REDLAND SUBDIVISION

Re: Redland Estates

POADP # 606

The City Staff Development Review Committee has reviewed Redland Estates Subdivision Preliminary Overall Area Development Plan # 606. Please find enclosed a signed copy for your files. Although your plan was accepted, please note the following:

P.U.D. PLAN/P.O.A.D.P.

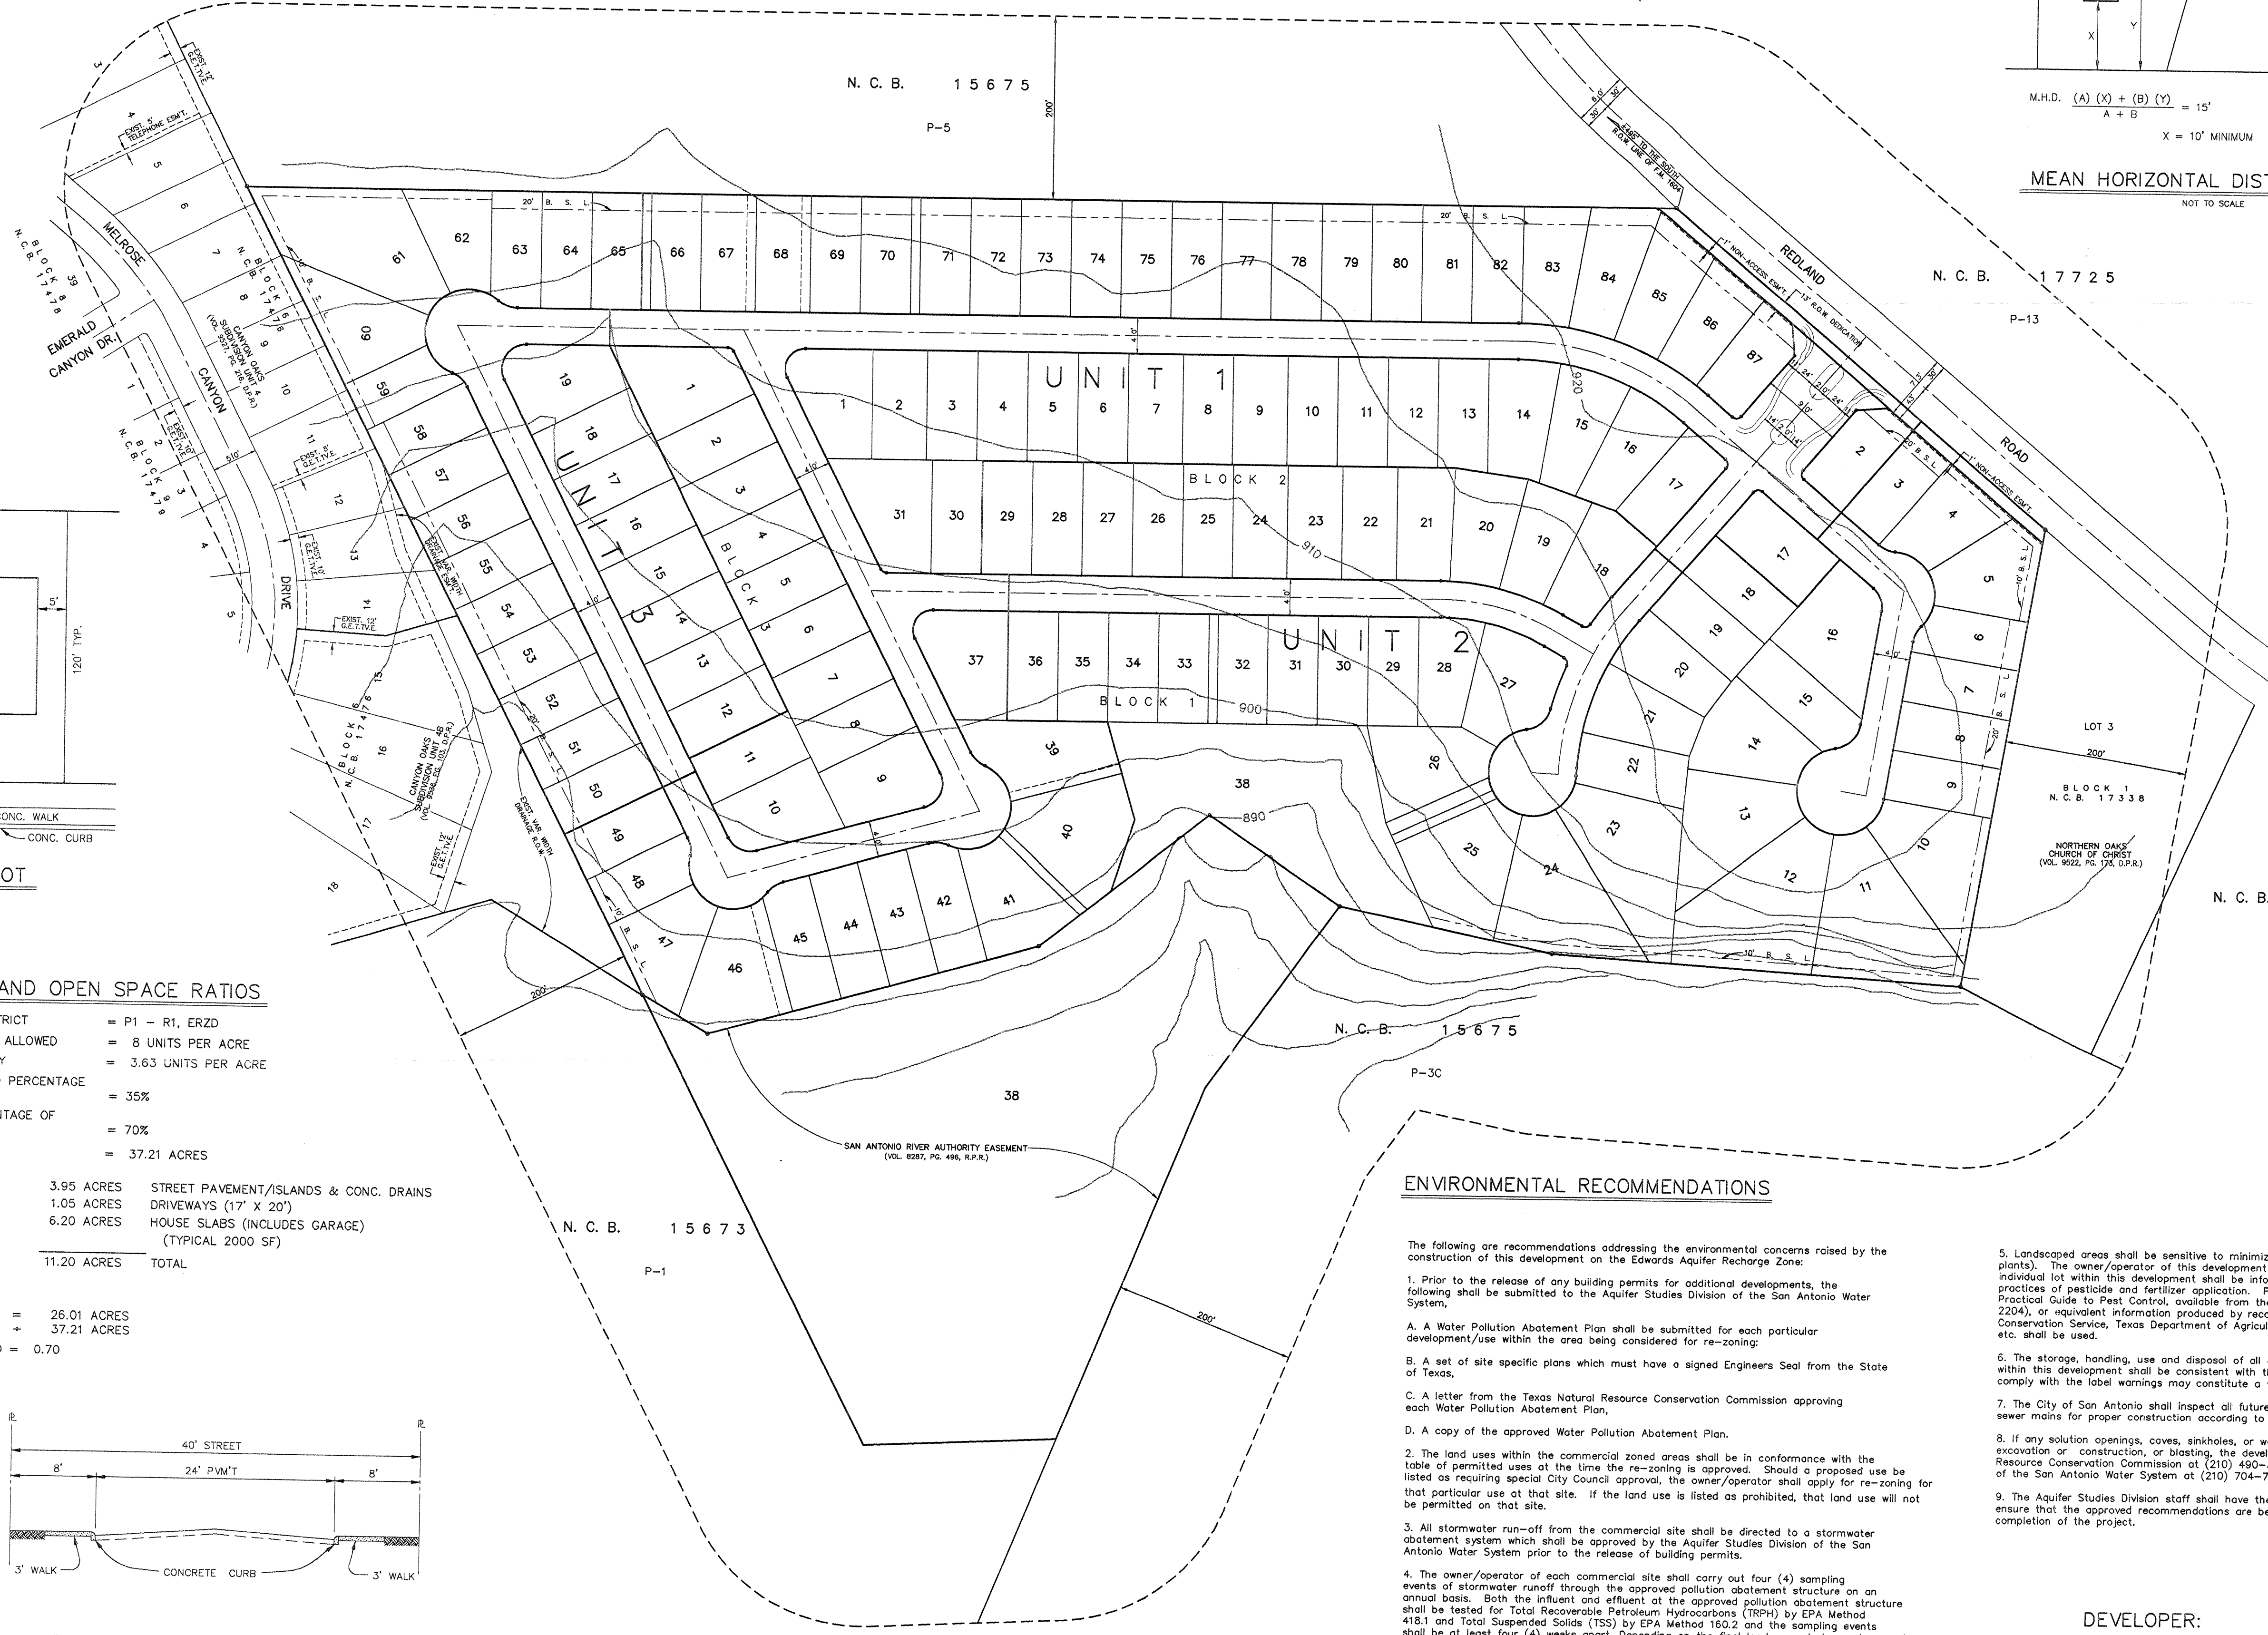
- Based on the topography, a Flood Plain Study and drainage review will probably be required during the platting process.
- This development will probably need to conform to requirements associated with development over the Edwards Aquifer. For additional information about these requirements you can contact SAWS at 704-7305.
- This development will need to comply with tree preservation ordinance #85262. For information about these requirements you can contact Building Inspections at 207-7102.
- It will be expected that you will plat all of the property depicted in your POADP, to include: floodpains, drainage areas and open space.
- I would encourage you to work closely with the school district, so that they can plan accordingly.

Flood plain requirements and drainage
assessment will be addressed during the
planning process.
